**CULTURAL RESOURCES OFFICE  
 PRESERVATION BOARD  
 REGULAR MEETING  
 MONDAY DECEMBER 15, 2014 — 4:00 P.M.  
 1520 MARKET ST. #2000  
 ST. LOUIS, MISSOURI 63103  
[www.stlouis-mo.gov/cultural-resources](http://www.stlouis-mo.gov/cultural-resources)**

DATE: December 15, 2014  
 ADDRESS: 1219 Dolman Street  
 ITEM: Preliminary Review: New construction, single-family house  
 JURISDICTION: Lafayette Square Certified Local Historic District — Ward 6  
 STAFF: Jan Cameron, Cultural Resources Office

DATE: December 15, 2014  
 ADDRESS: 4055 Flora Place  
 ITEM: New Application to retain landscape retaining walls  
 JURISDICTION: Shaw Neighborhood Local Historic District — Ward 8  
 STAFF: Andrea Gagen, Preservation Planner, Cultural Resources Office

DATE: December 15, 2014  
ADDRESS: 462 N. Taylor Avenue  
ITEM: New Application: Erect two pylon signs  
JURISDICTION: Central West End Historic District — Ward 28  
STAFF: Jan Cameron, Cultural Resources Office

**SITE PLAN**

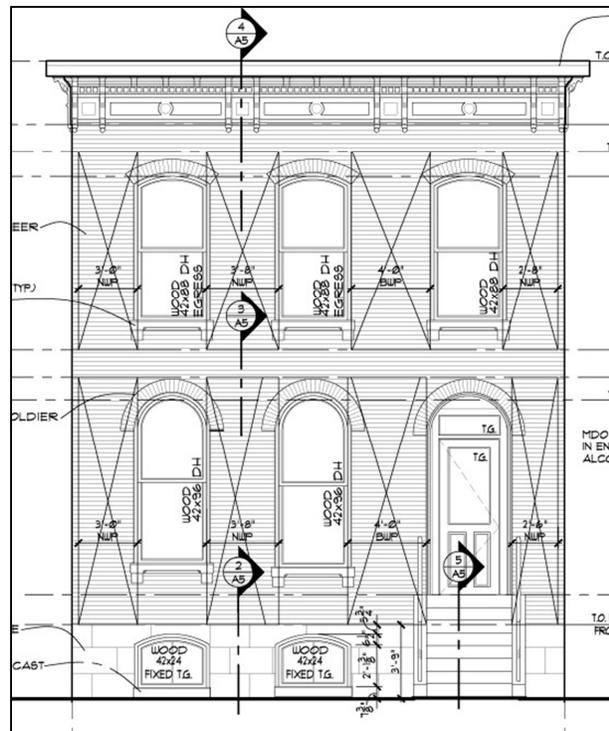
**The site plan meets the standards for alignment and setback.**

**FRONT ELEVATION**

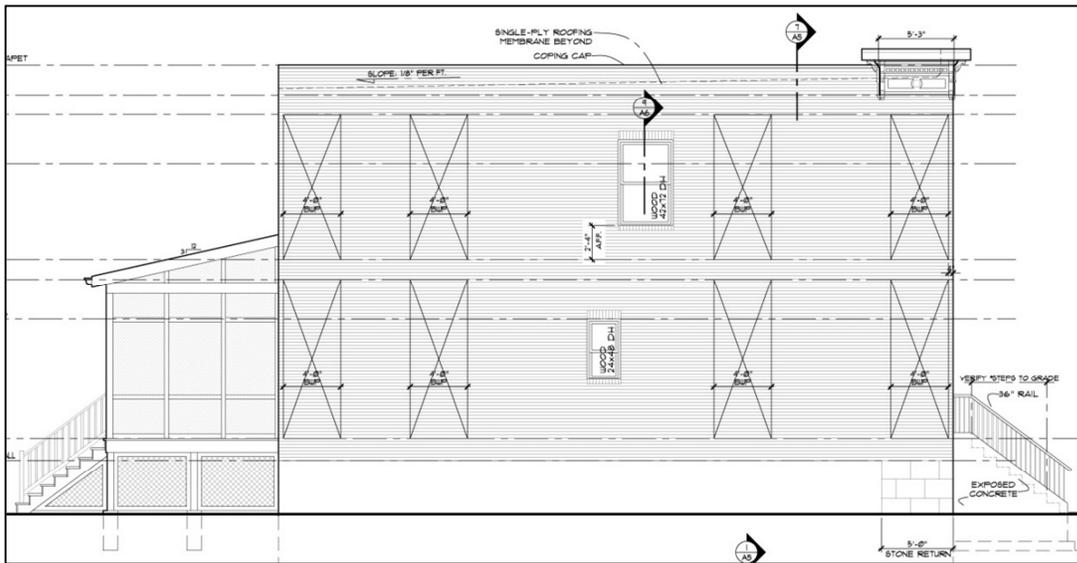
**Windows of the front and south elevations will match those of the HME.**

**The windows to be used on the façades will have arched heads: semi-circular on the first story, and segmental on the second, following the HME. The windows will be approved by the CRO as to materials, dimensions and profiles similar to those of the HME, and have the correct brick mold.**

**SOUTH ELEVATION**

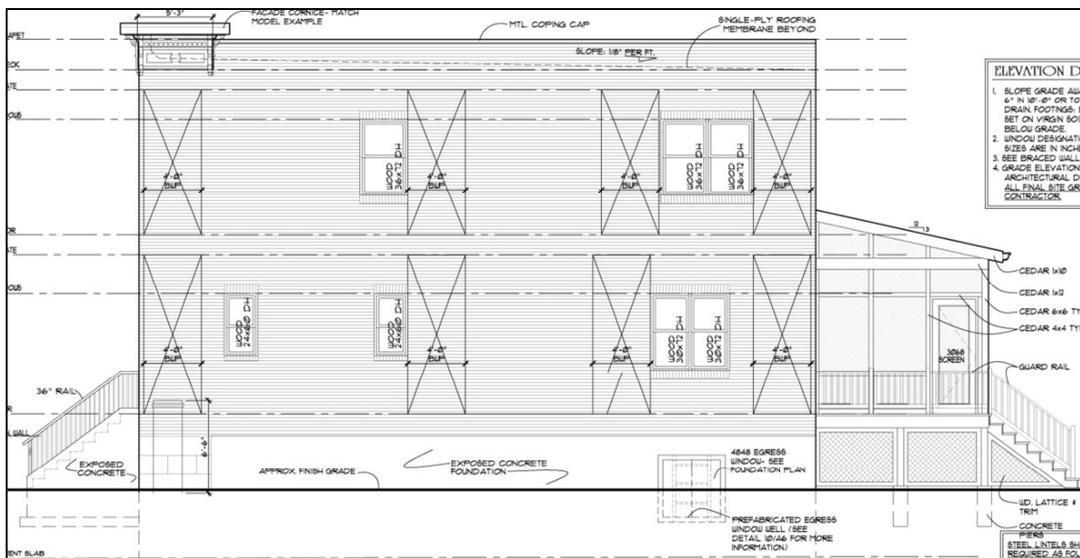
**Some variance from a strict replication of side fenestration of the HME has been accepted on most of the approved infill buildings on Dolman Street, limited primarily to the rear half of the building. This design proposes paired windows at the rear and a smaller bathroom window on the south elevation.**

14'-6" PYLON SIGN PROPOSED FOR CORNER OF PARKING LOT

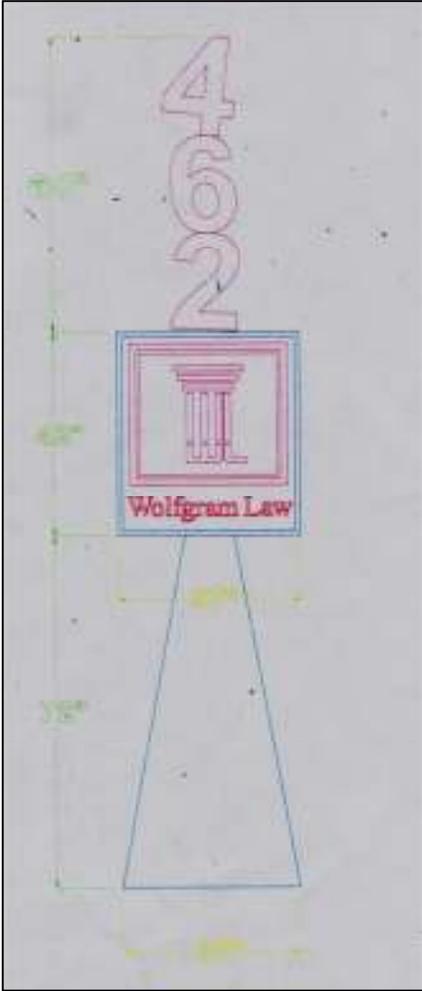
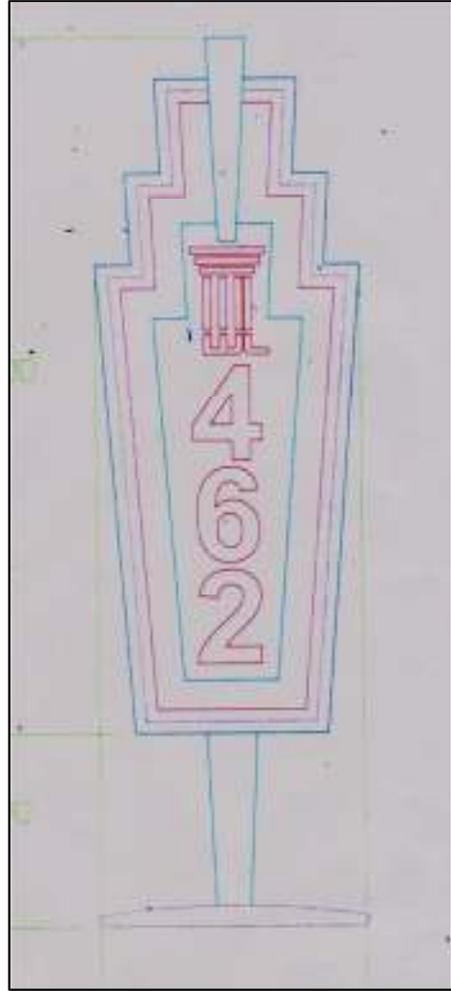
- The 6'4" sign proposed at the main building entry will be freestanding, but placed within inches of the building façade. This condition helps it to be seen as an attached sign, but avoids impacts to the masonry through its installation.

- The standards do not allow pylon signs of any description.
- The proposal does not meet the criteria for being a corner storefront for which two signs are permitted, one on each façade as the building is not at the corner and the sign in the parking lot will not be on the building.

- The larger sign, also a pylon sign, violates height limitations in the zoning. While it is appurtenant to the property, the standards indicate that signs would be on commercial buildings.

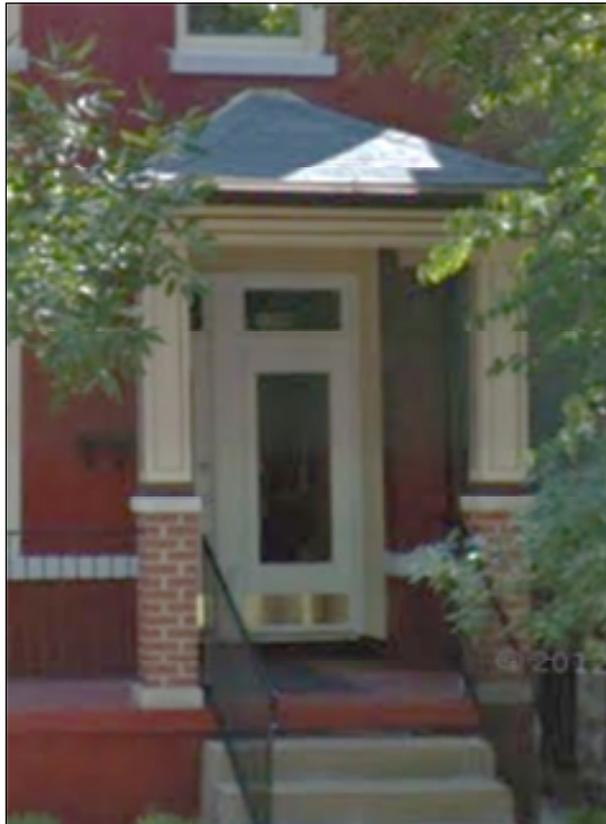
**Does not comply. The owner replaced the compliant paired front entry doors and transoms with a contemporary single centered door with flanking side-lights and single transom without a building permit. The new installation has decorative glass on the door, transom and sidelights that is inappropriate for the style of the house and detracts from the overall appearance of the building. The new doors are not based on a Model Example.**

**Does not comply. The existing transom configuration was paired. The owner replaced them and installed a single large window that spanned the length of the entryway.**
